Groundwater Application Review Summary Form

Application # LL- 1966

PUBLIC INTEREST REVIEW FOR GROUNDWATER APPLICATIONS

TO: Water Rights Section Date 8/21/2024
 FROM: Groundwater Section Aaron Orr / Travis Brown
 Reviewer's Name
 SUBJECT: Application LL- 1966 Supersedes review of _____
 Date of Review(s)

Water-Level Measurements in Nearby Wells

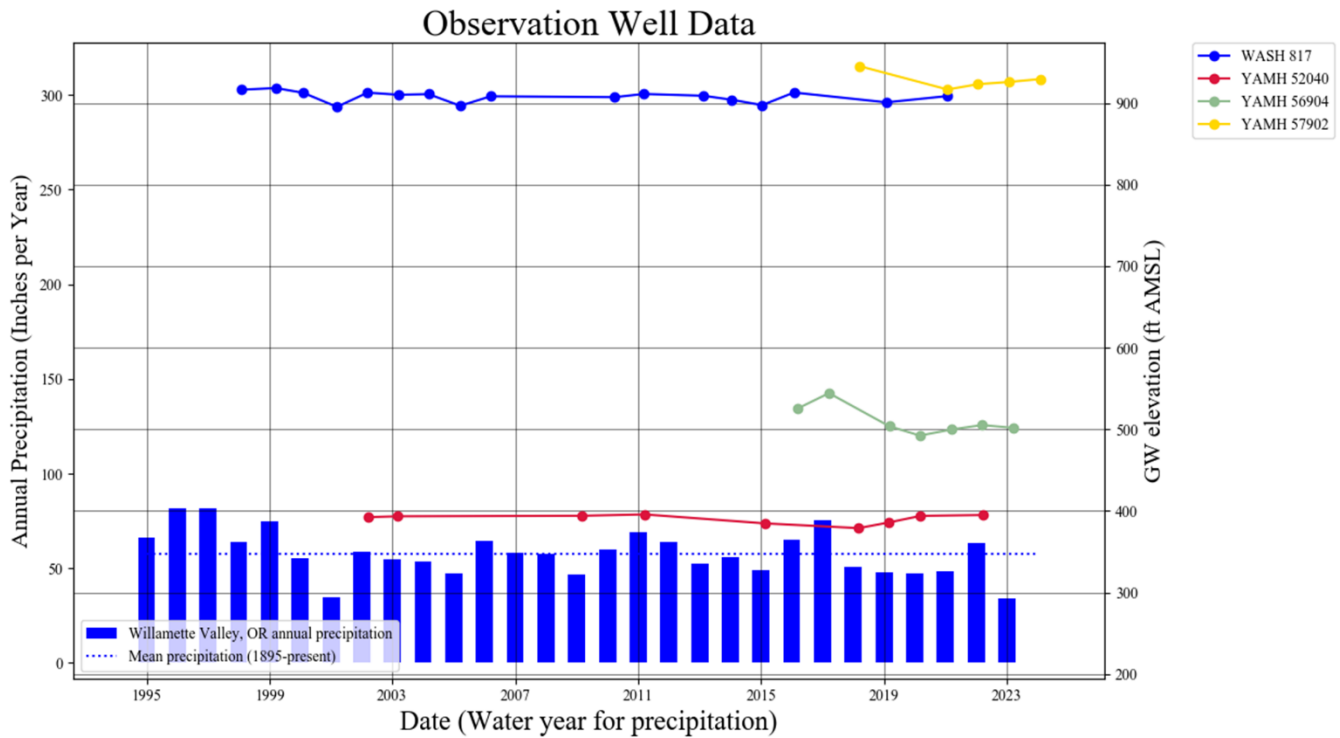
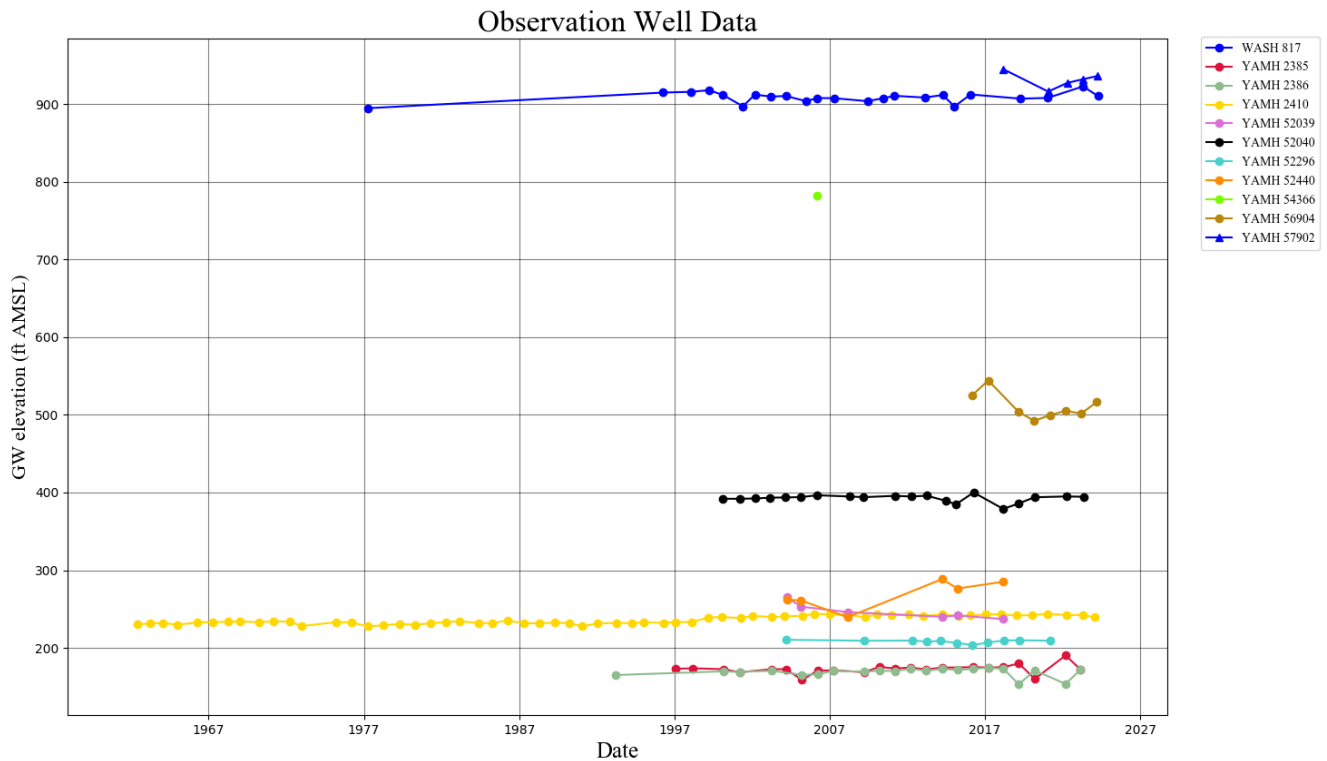
Basalt wells with water level data within 3 miles of the proposed POAs show varying water level trends. These data are from wells that are both on the northeast and southwest side of the Chehalem Mountain Ridge. The well that is the closest comparison for the proposed POAs is YAMH 52040 (southwest of the ridge), which was drilled in the landslide complex and is completed in CRB. WASH 817 (northeast of the ridge) and YAMH 52040 both show relatively stable water levels. YAMH 56904 and YAMH 57902—which are closer to the POAs but drilled northeast of the Chehalem Mountain ridge—show substantial decline between 2017 and 2021 and appear to have slightly recovered in the past four years. Water levels in 56904 have tripped declined excessively conditions (52 feet of decline between 2017 and 2020). Water levels in YAMH 57902 declined 29 feet between 2018 and 2021. Though closer wells exhibit signs of declining water level conditions, the aquifer system(s) on the northeast side of the Chehalem Mountain ridge likely do not have good hydraulic connection with the POAs on the southwest side of the ridge that is completed in the “Chehalem Bench.” Furthermore, wells greater than 3 miles from the POAs but completed in the “Chehalem Bench” show generally stable trends. Therefore, water levels in the area of the POAs completed on the southwest side of the Chehalem Mountains are likely stable.

Figure 1: POA 1 (Well 1A)

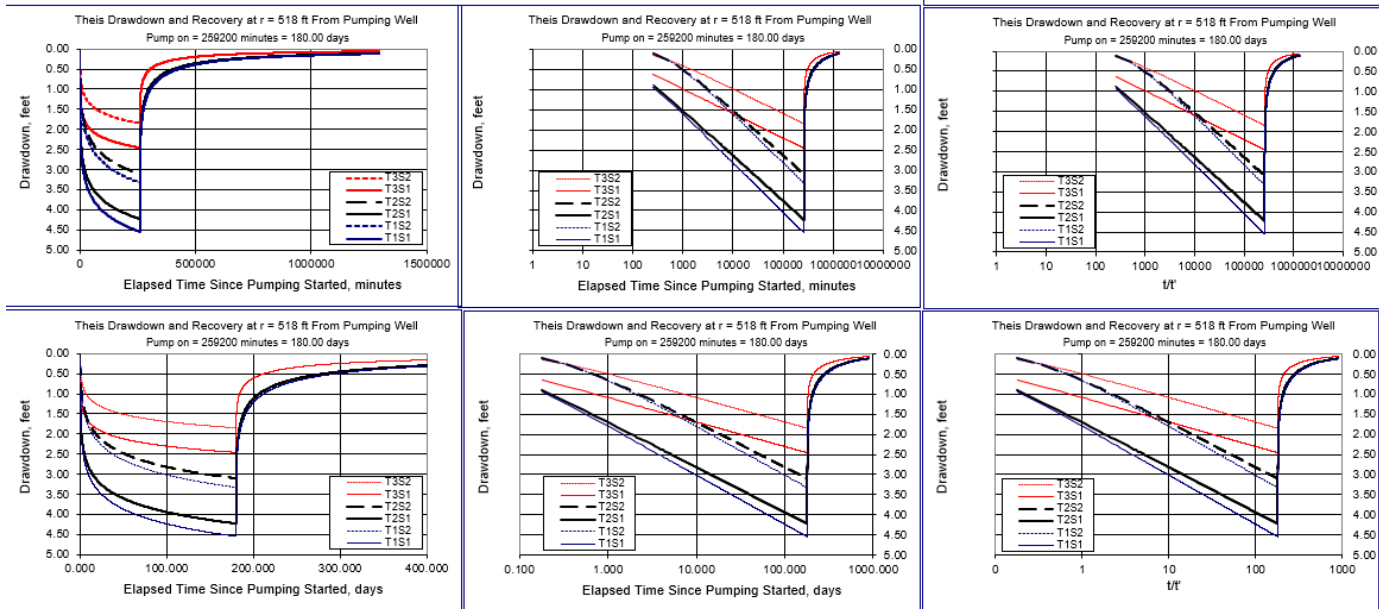
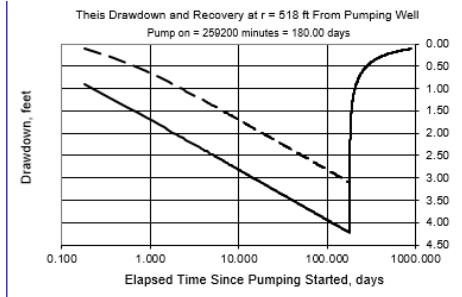
Given a rate of 0.027 cfs for either POA 1 or POA 2, nearby wells are estimated to experience less than 3 feet of drawdown over a 244-day (irrigation) pumping period. The nearest known wells completed in the same aquifer as the proposed POAs are YAMH 54988, at least ~400 feet southwest of POA 1 and YAMH 2098, at least ~518 feet north of POA 2. Breakdowns of each parameter are described in the **Theis Interference Analysis** section of the appendix.

Distance: 518 feet from POA 1 to YAMH 2098, 410 feet from POA 2 to YAMH 54988.
